UNITED STATES
NUCLEAR REGULATORY COMMISSION
WASHINGTON, D. C. 20555

FACILITY: Palo Verde Nuclear Generating Station, Units 4 and 5

SUBJECT: SUMMARY OF MEETING HELD ON OCTOBER 17, 1978 REGARDING THE
SAFETY REVIEW OF PALO VERDE, UNITS 4 AND 5

REQUEST FOR ADDITIONAL INFORMATION

SUBJECT 80-Acre Storage Reservoir Failure Flood Study

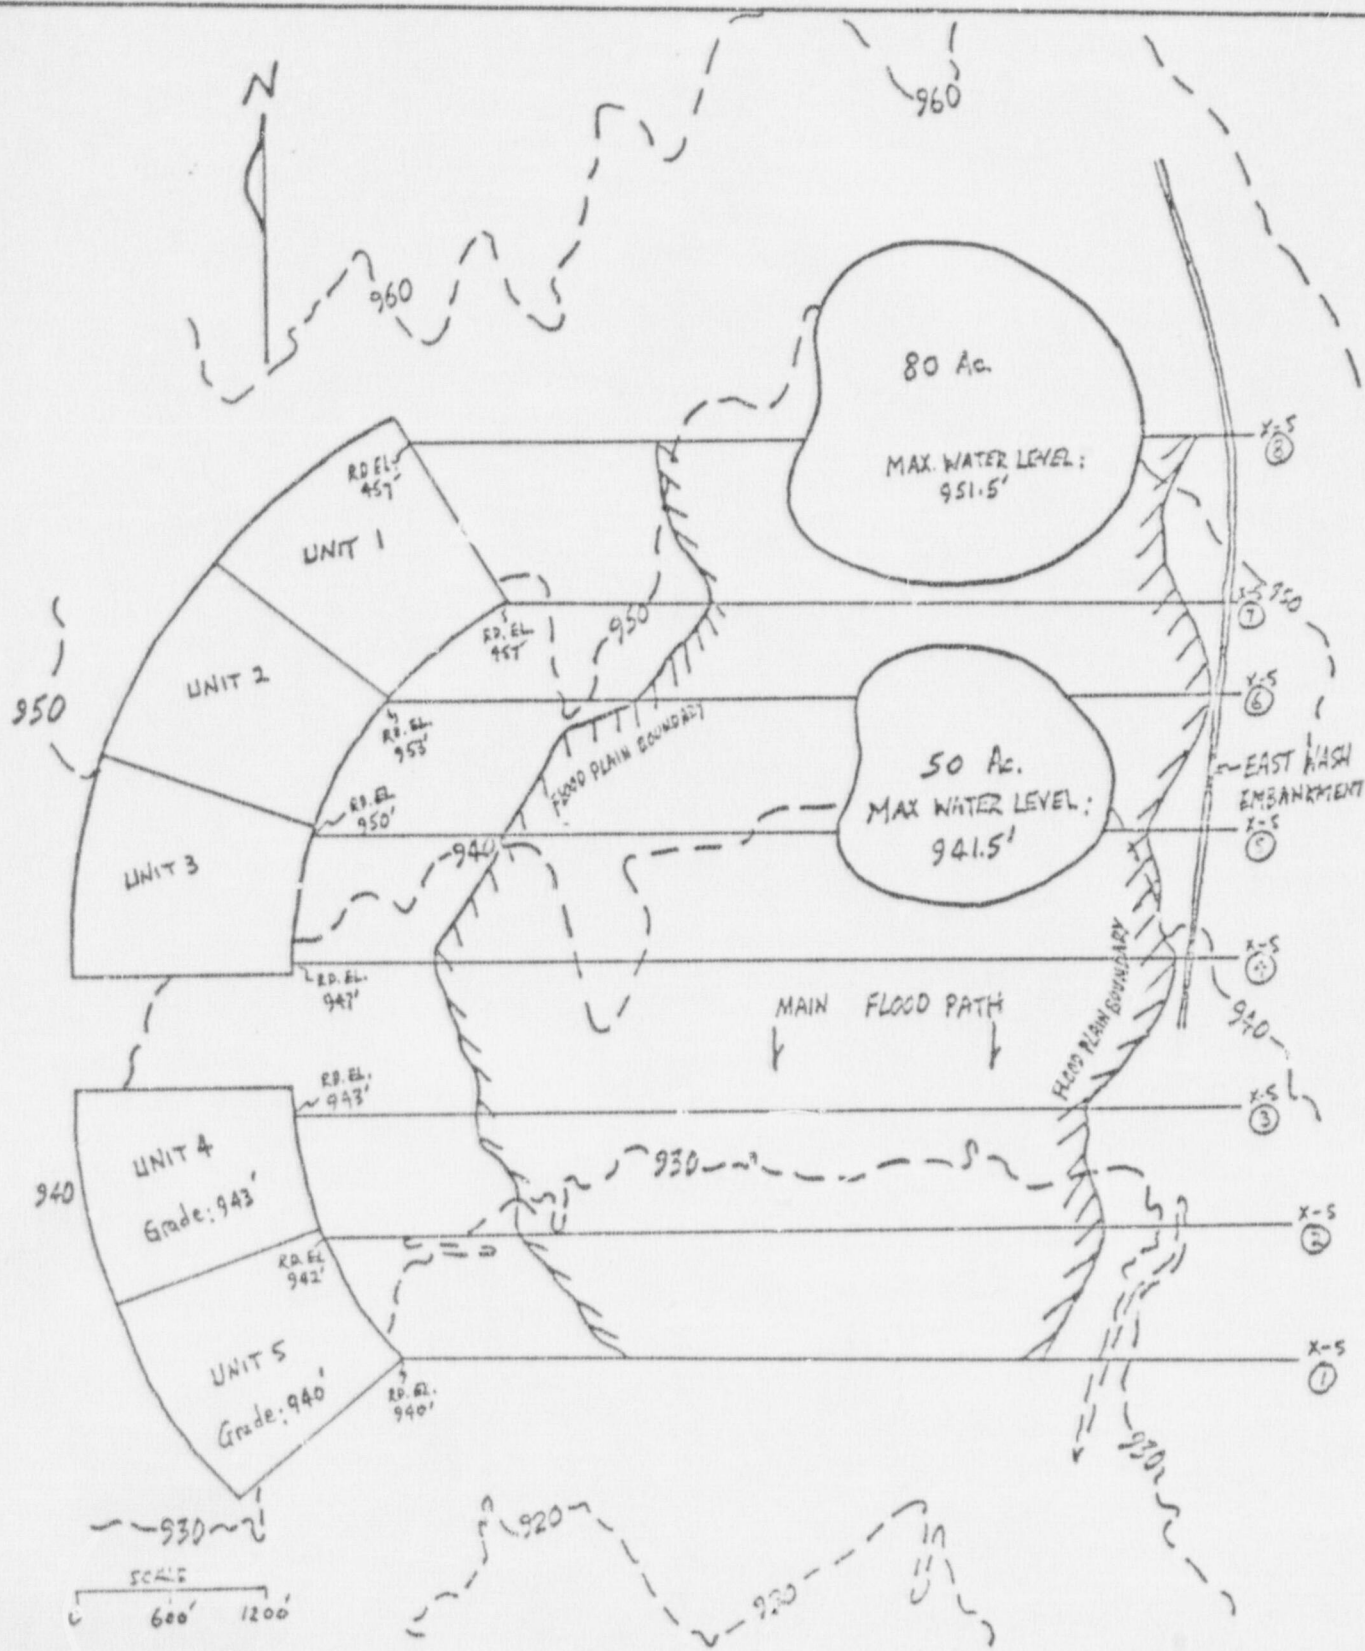
Provide the cross sections used in determining the extent of flooding during a postulated failure of the 80 acre reservoir. Provide documentation of the methods used to determine the starting water level used in the backwater analysis and the peak discharge of the dam-break wave. Provide the basis for your analysis and for all assumptions used in determining the water surface profile at the plant, including as a minimum, Mannings "n" values, slopes, transition losses and routing coefficients.

The proposed Units 4 & 5 plant site is located about 6000 feet southwest of the 80-acre storage reservoir (see attached drawing). The terrain between the plant and the reservoir has a slope of about 0.0037 descending in a general north-to-south direction. In the event of a postulate failure of the 80-acre storage reservoir, the main flood path would be in the low valley stretch located between the East Wash embankment and the Unit areas. The 80-acre storage reservoir has a maximum design water level of 951.5 feet which is 9.5 feet above the ground grade of 942 feet. This above-ground portion of water, approximately 738 ac-ft.,

- 1) A total of eight (8) cross-sections (see attached drawing) were used to represent the land terrain characteristics.
- 2) Field reconnaissance has shown that the Manning "n" coefficient of the land surface ranges from 0.035 to 0.050. For conservative purpose, a Manning's n of 0.05 was used.
- 3) The starting water level was estimated by the model using the slope-area method. The initial energy slope was approximated by using the average land slope (0.0037).

An iterative process was applied to input various peak discharges into the model until the total water volume under the calculated backwater flood profile is equivalent to the total above-ground water, 738 ac-ft., stored by the reservoir. When this condition is satisfied, the reservoir is considered to be drained out and the resulting backwater curve represents the maximum flood level downstream from the reservoir. In the calculation for the 80-acre reservoir break-down, a peak discharge of 150,000 cfs was observed to back up a total volume of 898 ac-ft of water. For conservative purpose, further attempts to reduce the total water volume to 738 ac-ft were not made.

The flood plain resulting from this 150,000 cfs peak discharge was delineated on the attached drawing. As shown, the maximum flood elevations approaching Units 4 & 5 are about 936 feet and 927 feet, respectively. Compared with the design plant grade of 943 feet at Unit 4 and 940 feet at Unit 5, it may be concluded that Units 4 & 5 are not subject to flooding due to failure of the 80-acre storage reservoir.
